DESCRIPTION OF DESIGN AND/OR PROCESS CHANGE

CGHV96100F2

Figure 1. Overall View::

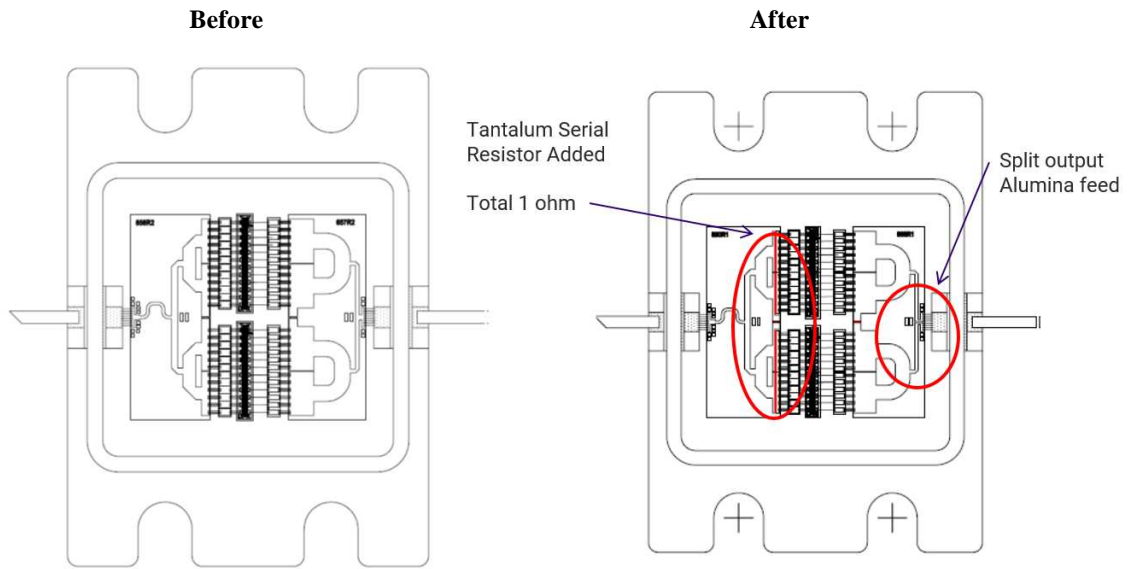
In order to eliminate the possibility of oscillation at -40°C at certain frequencies, Cree made changes to the design of the CGHV96100F2. A resistor was added to the input substrate. The combining circuit on the output substrate was also slightly modified. All other metallization on the substrates is the same. There is no impact to device reliability.
